From: John J. Sipos <John.Sipos@ag.ny.gov>
Sent: Monday, March 31, 2014 5:58 PM
To: RulemakingComments Resource; McConnell, Keith;
'Andrew.Imboden@nrc.gov'
Subject: NRC-2012-0246; Errata to Additional Comments by NYS OAG
Attachments: 2014 03 31 Errata (for 12-20-13 Add'l Comments).pdf; pages (reflecting errata corrections for 12-20-13 Add'l Comments).pdf

Consideration of Environmental Impacts of
Temporary Storage of Spent Fuel After
Cessation of Reactor Operations

RIN 3150-AJ20
NRC-2012-0246

ERRATA TO
STATE OF NEW YORK OFFICE OF THE ATTORNEY GENERAL ADDITIONAL COMMENTS ON
NRC STAFF'S DRAFT WASTE CONFIDENCE GENERIC ENVIRONMENTAL IMPACT
STATEMENT AND PROPOSED RULE

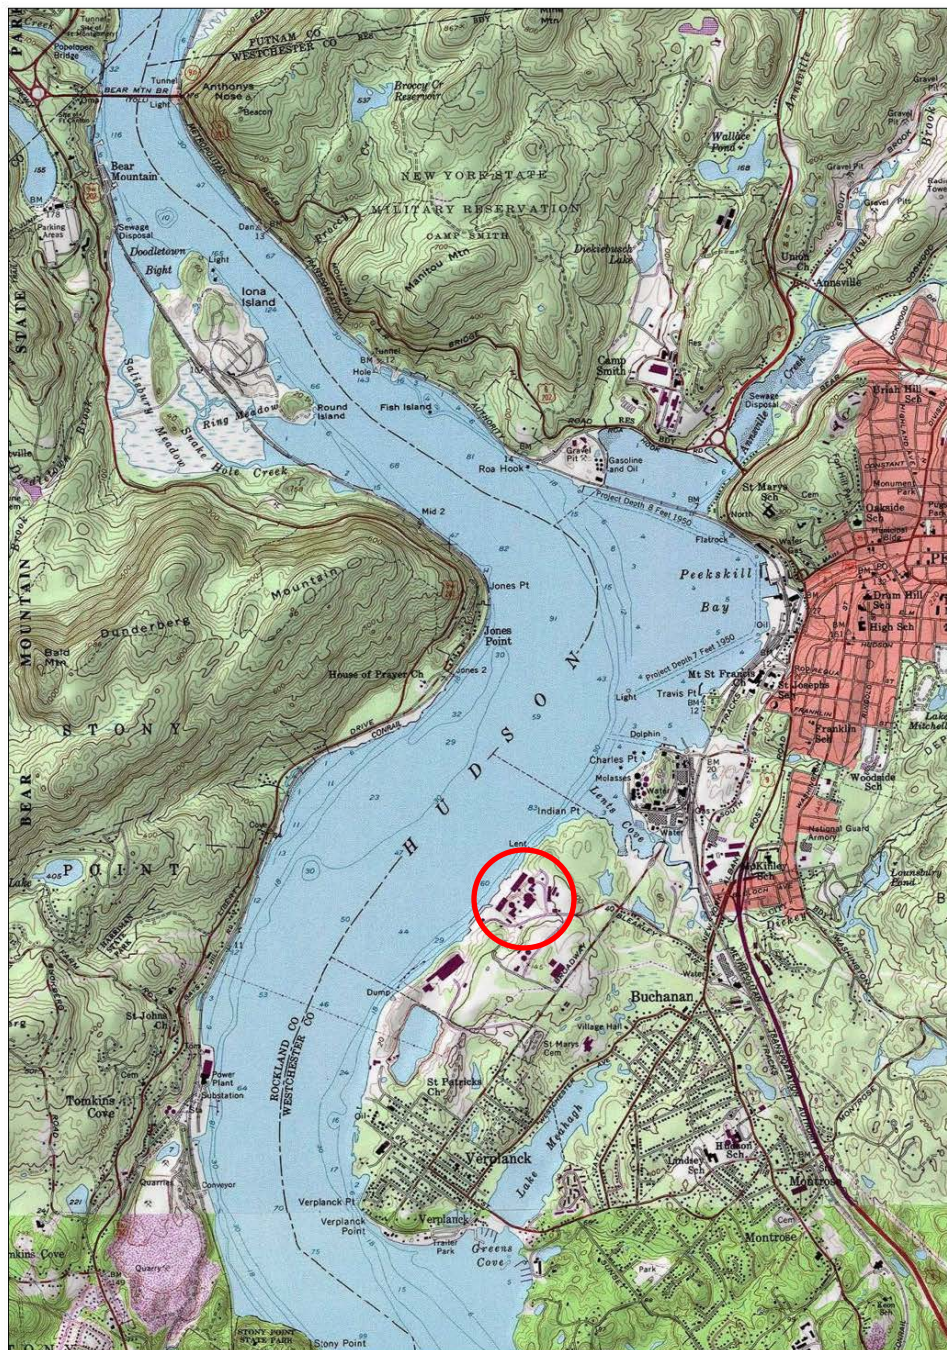
Page	Line	Now Reads	Should Read
1	7	accidents at the Indian Point	accidents at Indian Point
7	Map	[red circle]	[move approximately ½ inch to the northwest]
11 n 3	3	Revolutionary War Sony Point	Revolutionary War Stony Point
12	11	peer-reviewed by Dr. Sykes	peer-reviewed article by Dr. Sykes
13	4	NRC that earthquake hazard in the	NRC that earthquake hazards in the
13	5	Rocky Mountains, was	Rocky Mountains, were
16	20	Point Unit 2	Point Unit 3
20	16	However, under NEPA, analysis	However, NEPA requires analysis
30	2	below on page 26	below on page 43
45	4	, The recent	The recent
56	13	reflected in the revised GEIS for license renewal.	reflected in a revised EIS and rule.
63	1	'Alvarez et al.	Alvarez et al.
65	7	mentioned above on pages 37-38	mentioned above on pages 54-55
75	21	the 1972 attach at the	the 1972 attack at the
82	2	and are plainly	and is plainly
